To J. R. Holcomb
 From Al Peck
 Date October 11, 1974
 Subject Relocation of Laboratory VCM Vents

Attached is a revised process design to route two laboratory VCM vents to the existing VCM vent header system in the tank farm area. This design is being issued as final unless further comments are received.

FIGURE 1
 RELOCATION OF LABORATORY SAMPLE VENT
 LABORATORY VENT APPARATUS MODIFICATIONS
 ARP
 OCTOBER 8, 1974

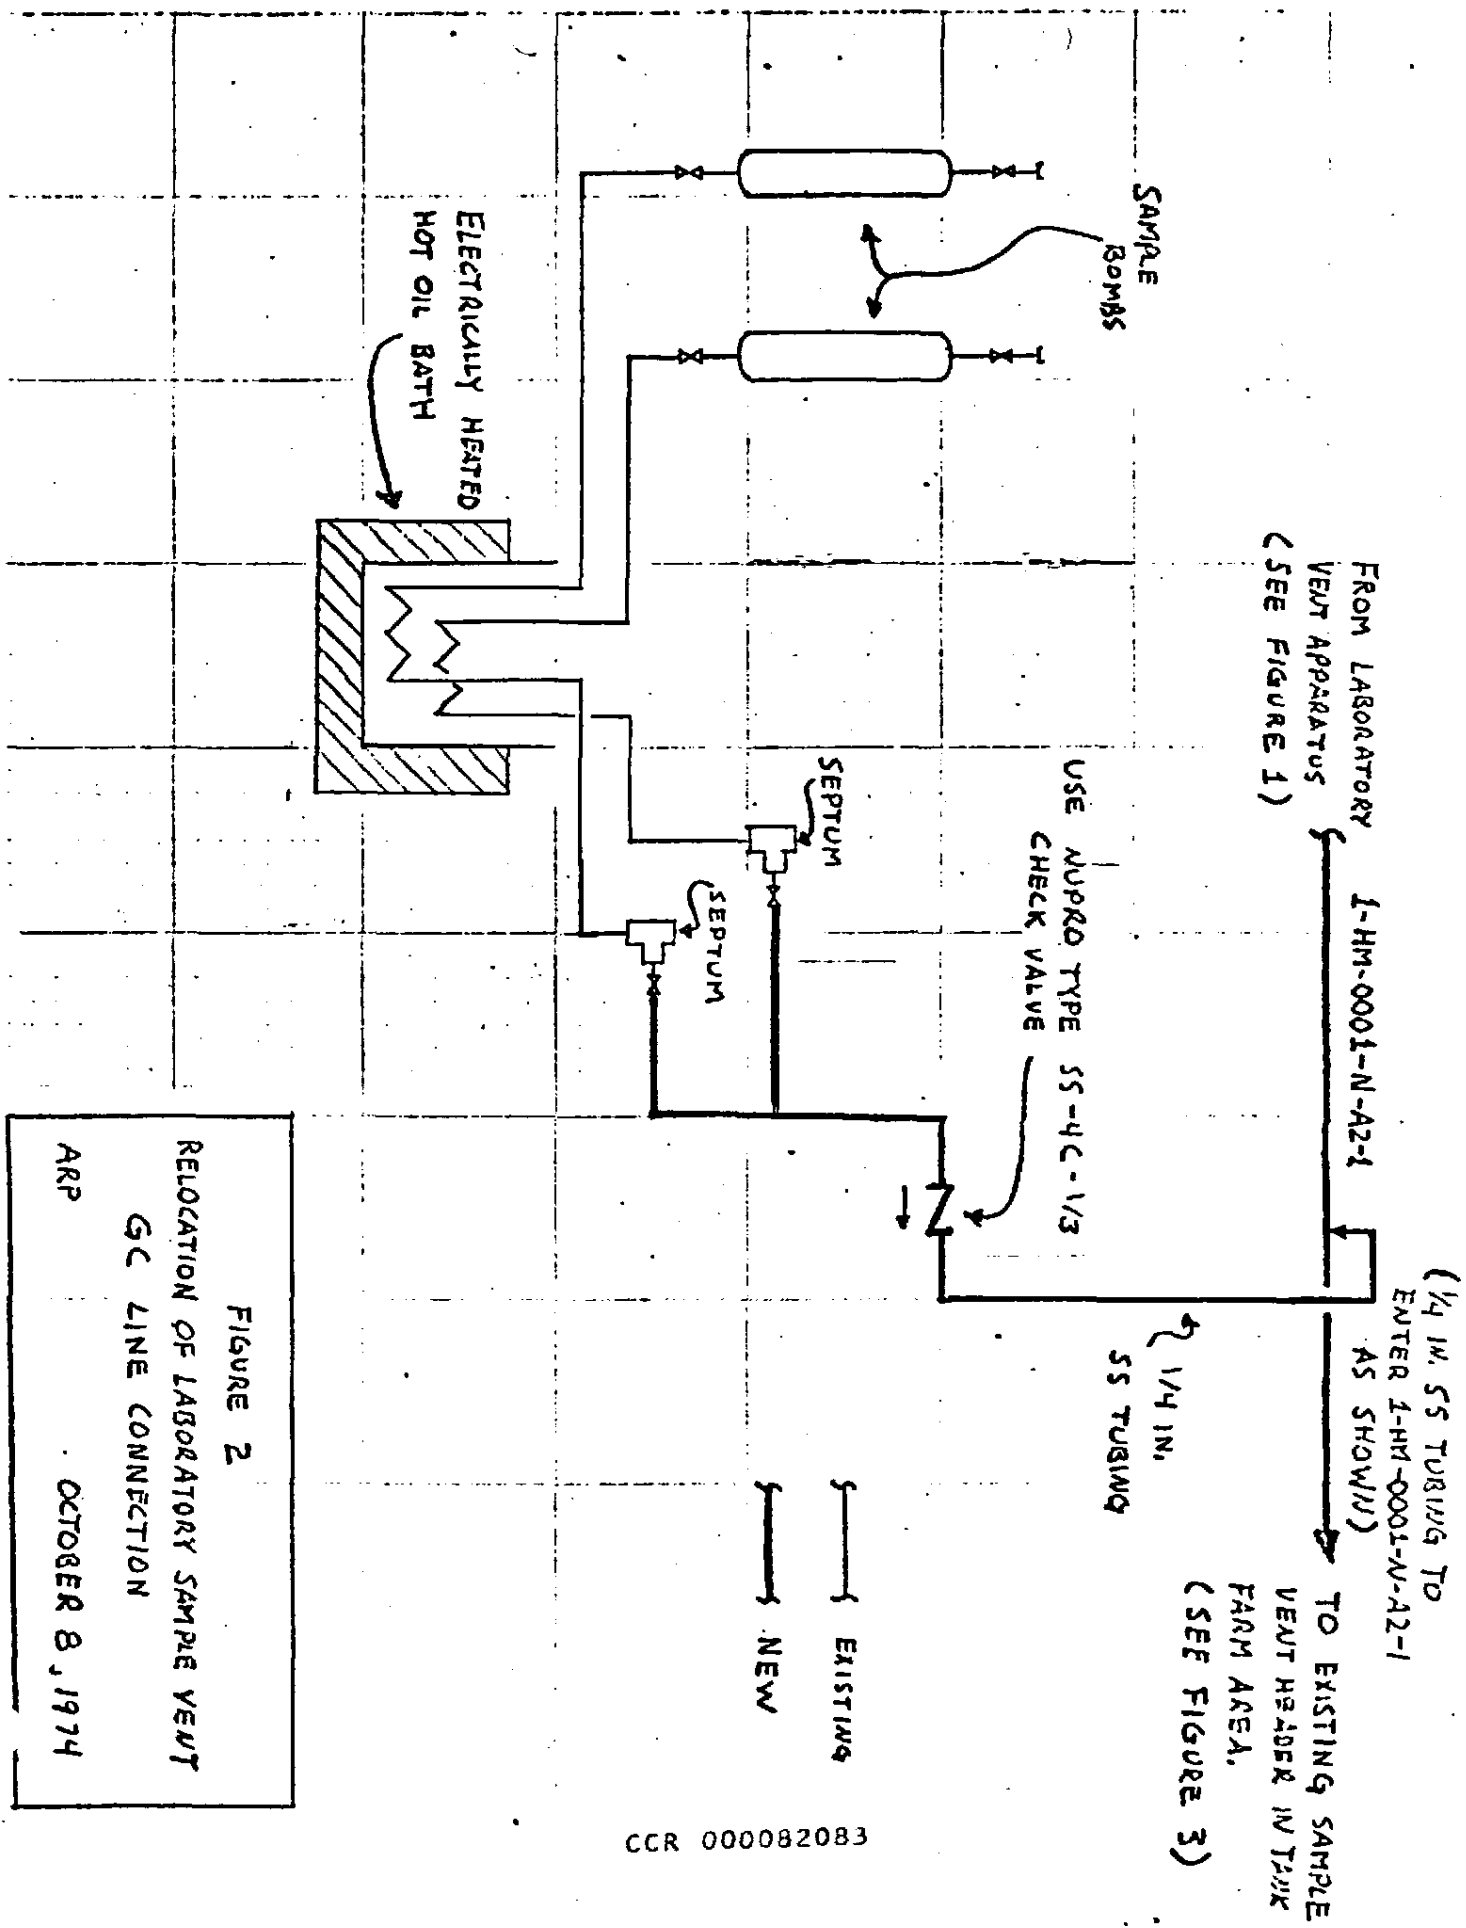
A. Laboratory Hood Apparatus Modifications (Figure 1)

The steam and vacuum lines are to be disconnected from the VCM venting manifold and sealed. A separate steam system to clean one bomb at a time should be built complete with tubing connections and a holder. After the vacuum line to the venting manifold is disconnected the present vacuum system will still permit evacuation of one bomb at a time. A pressure gauge and valve will be added. The gauge will be used to determine the manifold back-pressure and the valve used to throttle the flow to the vent. The operating procedure for use of this apparatus are describe on Figure 4 and 5.

FIGURE 2

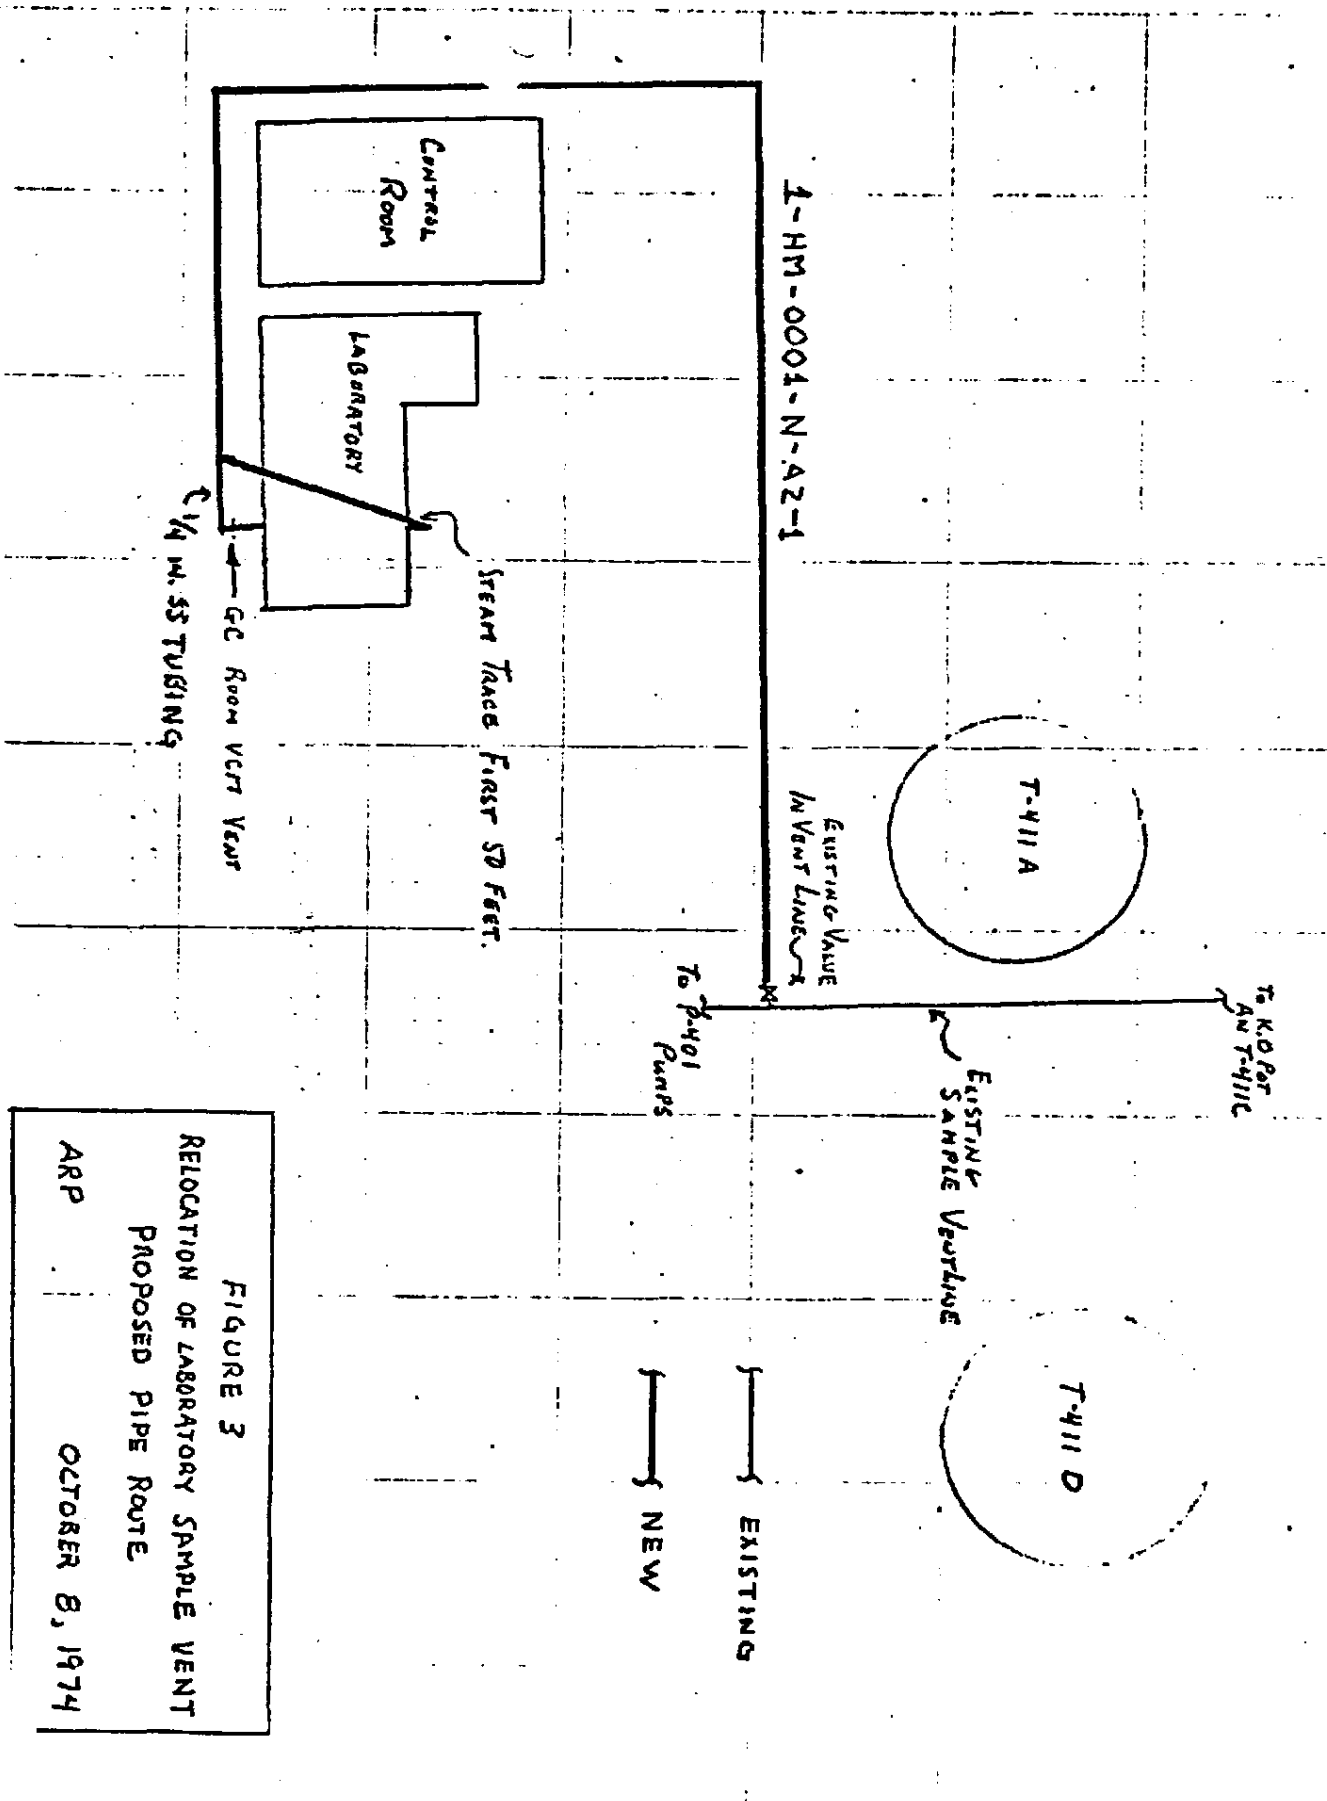
B. Laboratory GC Sampling System Changes (Figure 2)

The GC sampling system vent will require new stainless steel tubing and a check valve as shown. The tie-in to the vent line is also shown.

FIGURE 3

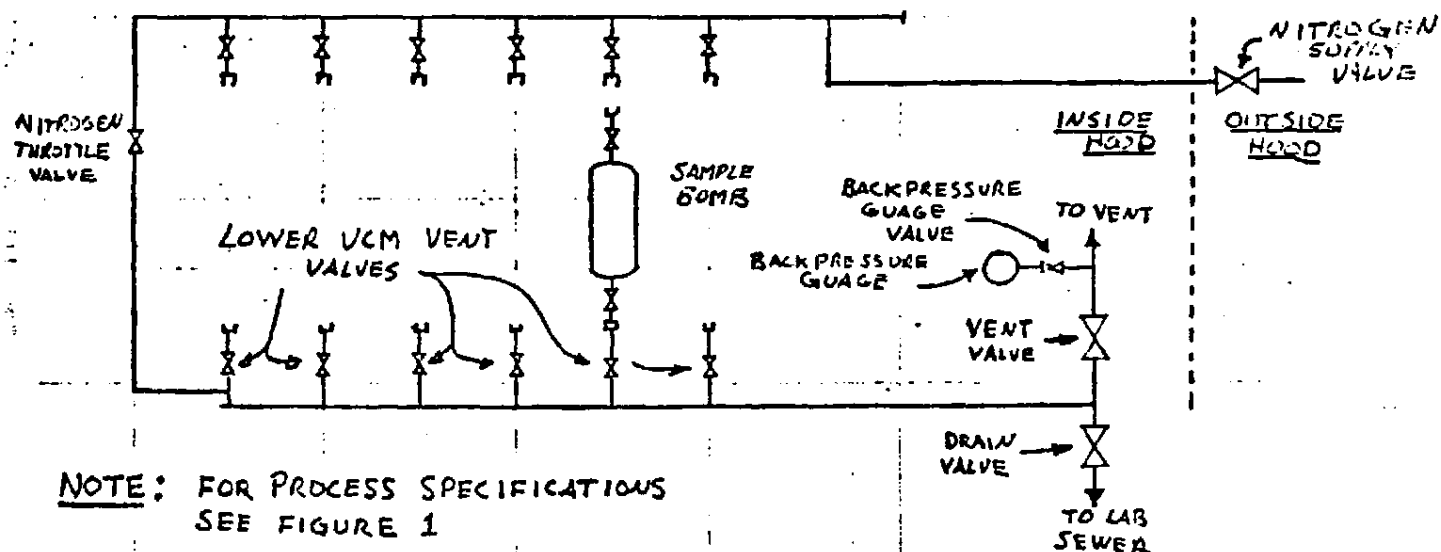
C. Vent Line (Figure 3)

The laboratory VCM vent is to be routed to the pipe rack on the north side of the building. The GC sampling system vent should be tied in at this point. The line is then routed as shown to an existing valved connection on the VCM sampling system vent header. The first 50 feet of the pipe from the lab should be steam traced to vaporize any VCM liquid. Low points in the line should also be steam traced to vaporize any liquid that may become trapped at these low points in the line.
